Access Compliance Report Public Rights-of-Way (Curb Ramps)

Main Street: MORNING_TRAIL		Cross Street: CRYSTALAIRE		Location:	S
ADA ID: RPRK211019173800	Ramp Type: Type 4 - Parallel	Initial Pass/Fail: Fail	Overall Compliance: No	Severity Score:	30
Codes/Mitigation Info/Possible Solution			Field Measurements/Component Compliance

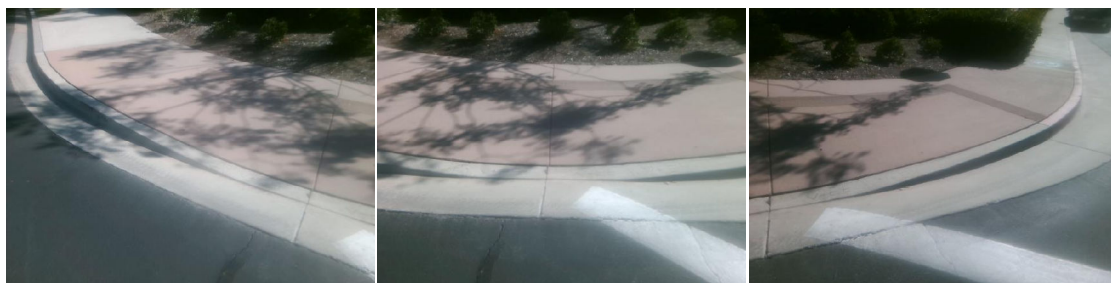
Compliance	Description	Data	Compliance	Description	Data
N/A	Ramp Length LT (in)	83	N/A	Ramp Length RT (in)	111
Yes	Ramp Width LT (in)	54	Yes	Ramp Width RT (in)	53
Yes	Ramp Run Slope LT (%)	8.1	Yes	Ramp Run Slope RT (%)	1.1
No	Ramp Cross Slope LT (%)	13.1	No	Ramp Cross Slope RT (%)	9.3
N/A	Landing Present	N/A	N/A	DWS Provided	N/A
N/A	Landing Length (in)	N/A	N/A	DWS Contrast	N/A
N/A	Landing Width (in)	N/A	N/A	DWS Length (in)	N/A
N/A	Landing Run Slope (%)	N/A	N/A	DWS Full Width	N/A
N/A	Landing Cross Slope (%)	N/A		DWS Offset Type	N/A
N/A	Landing Movement Obstructed?	N/A	N/A	DWS Offset Left (in)	N/A
	Landing Movement Type	N/A	N/A	DWS Offset Right (in)	N/A
N/A	Landing Shared	N/A			
N/A	Clear Space	Yes			
N/A	Clear Space To Crosswalk (in)	N/A			
N/A	Marked Crosswalk 1	No	N/A	Marked Crosswalk 2	No
	Crossing 1 Direction	NE		Crossing 2 Direction	NW
	Marked Crosswalk 1 Width (in)	N/A		Marked Crosswalk 2 Width (in)	N/A

Remove & Replace Curb Ramp With Two New Directional Ramps or Equivalent.
